Project	IEEE 802.16 Broadband Wireless Access Working Group < http://ieee802.org/16 >	
Title	Proposed changes to clause 15.1.3	
Date Submitted	2007-09-07	
Source(s)	Mariana Goldhamer Alvarion Ltd. 21A, HaBarzel St, 69710, Tel Aviv, Israel	Voice: +972544225548 E-mail: mariana.goldhamer@alvarion.com
Re:	Task Group Review	
Abstract	Summary of the Ad-Hoc activity	
Purpose	Approval	
Notice	<i>This document does not represent the agreed views of the IEEE 802.16 Working Group or any of its subgroups. It represents only the views of the participants listed in the "Source(s)" field above. It is offered as a basis for discussion. It is not binding on the contributor(s), who reserve(s) the right to add, amend or withdraw material contained herein.</i>	
Release	The contributor grants a free, irrevocable license to the IEEE to incorporate material contained in this contribution, and any modifications thereof, in the creation of an IEEE Standards publication; to copyright in the IEEE's name any IEEE Standards publication even though it may include portions of this contribution; and at the IEEE's sole discretion to permit others to reproduce in whole or in part the resulting IEEE Standards public

Figure h23—Initialization procedures — BS

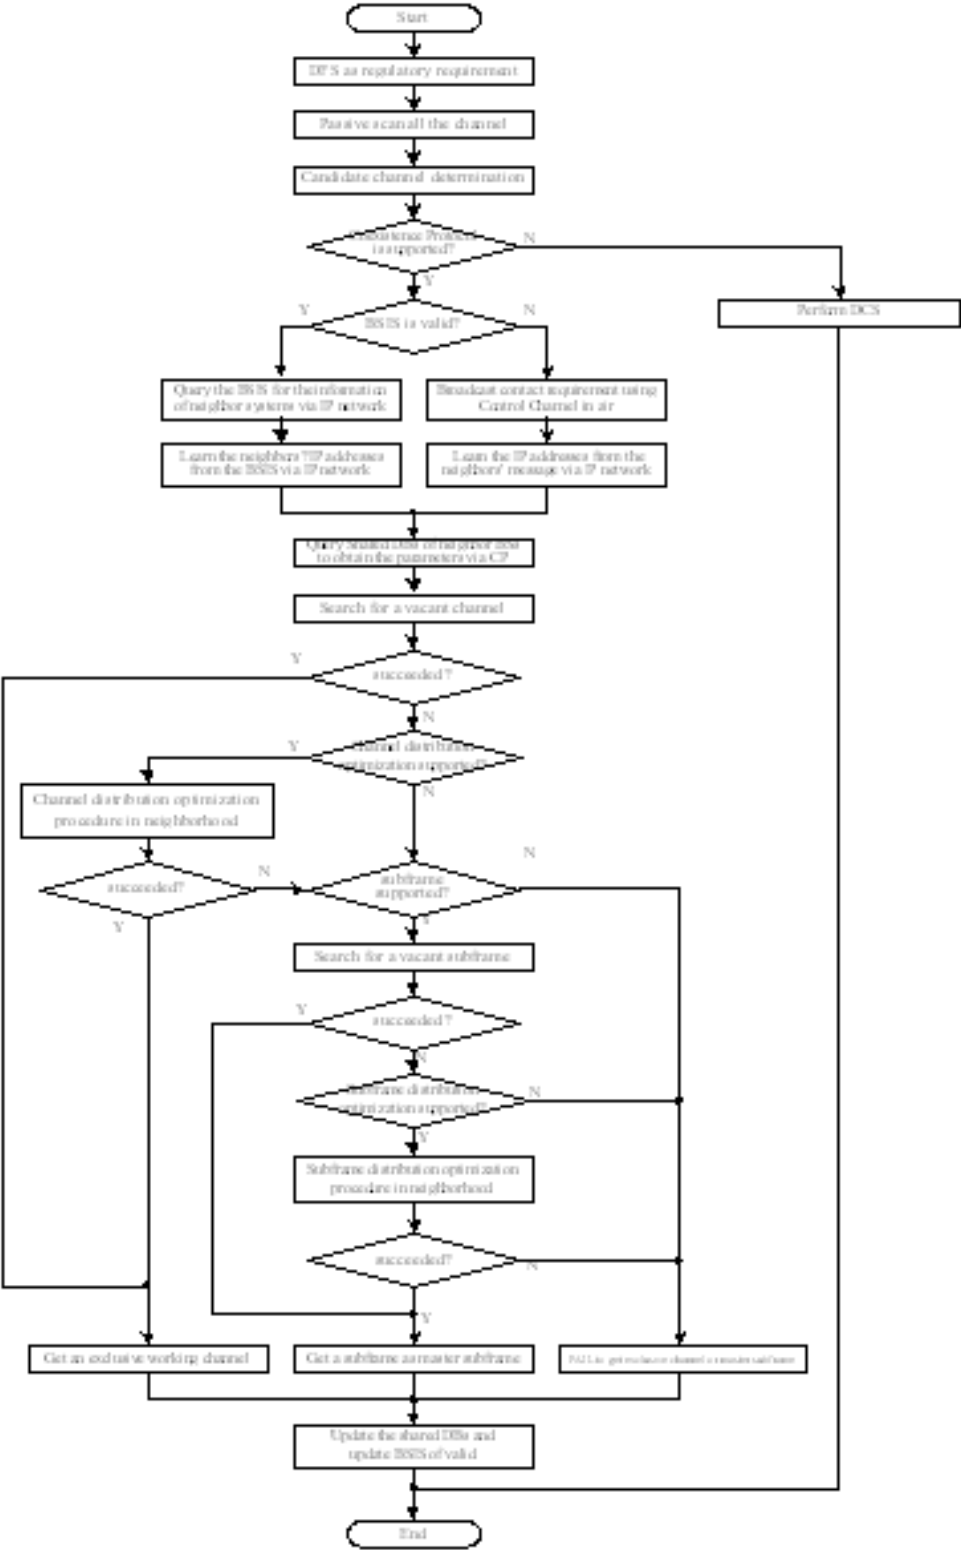
Creation of sub-frame is no more considered given the new CX Frame structure.

2) Update accordingly the Figure h16 (fig. h23 in D2c)

Similarly to the channel allocation, the IBS will then first try to find a vacant sub-frame in the potential channels using the information of the distributed database; if it fails the IBS will then try to vacate an exclusive existing sub-frame by sub-frame distribution optimization, if supported. If all these attempts fail, the IBS will not be able to get any interference free resource for operation.

Error! Reference source not found. shows the initialization procedures for the WirelessMAN-CX BSs. The detailed negotiation and update procedures are described in section **Error! Reference source not found.** and **Error! Reference source not found.**. Scan here is just an action taken on the each channel sequentially. The basic distinction between passive scan and active scan is in the specific action of scanning. Passive scan means measurement or monitoring of the potential channels, without any transmission. Active scan leads to signal transmission on each potential channel, and waiting for the responses.

Figure h24—procedure in the operating stage(A)

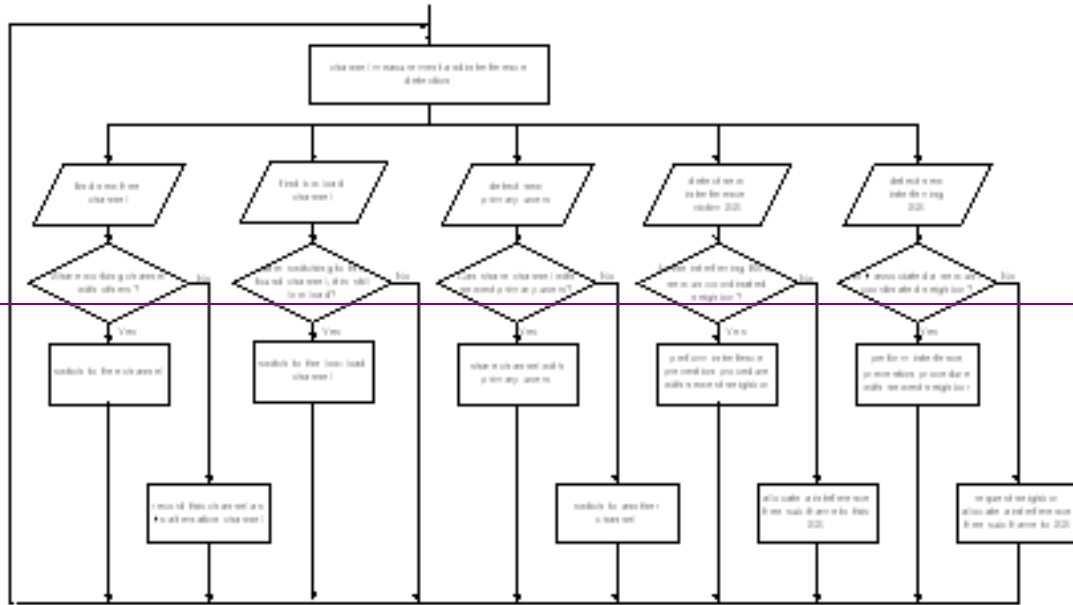
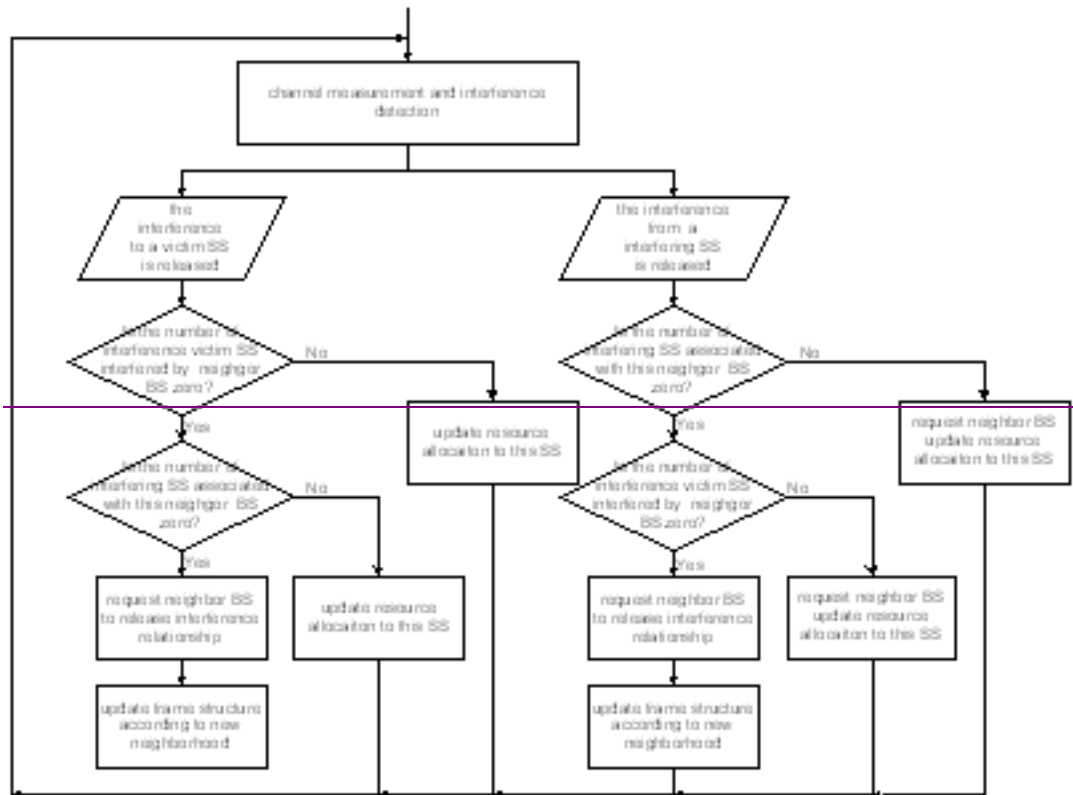
In the operating stage, the BS has SSs associated with it. ~~however, until the operating system parameters are determined, the co-channel or adjacent channel interference from WirelessMAN-CX BSs of different systems may still occur due to the detection of interference from Specific Spectrum Users (which may cause the neighbor BS to switch to an interfering channel).~~ Channel switching of coexistence neighbor systems or the entry of new coexistence neighbor BS might make the community so crowded that there are not enough channels. If the WirelessMAN-CX BS finds that there is no “free” channel at that moment, working channels may be reallocated, or the coexistence neighbor topology provides the guidelines of with whom it should negotiate to share the channel.

In the operating stage, system should monitor the channel status of its own working channel and other channels. ~~System may use quiet period, such as slave sub-frame, extended quiet period and quiet period in CX CCH slot for sensing and identification.~~ System will perform corresponding operation according to the result of channel measurement and ~~interference interferer~~ identity.

~~Figure h 24 Figure h 25 shows the procedure for the WirelessMAN CX BS in operating stage.~~
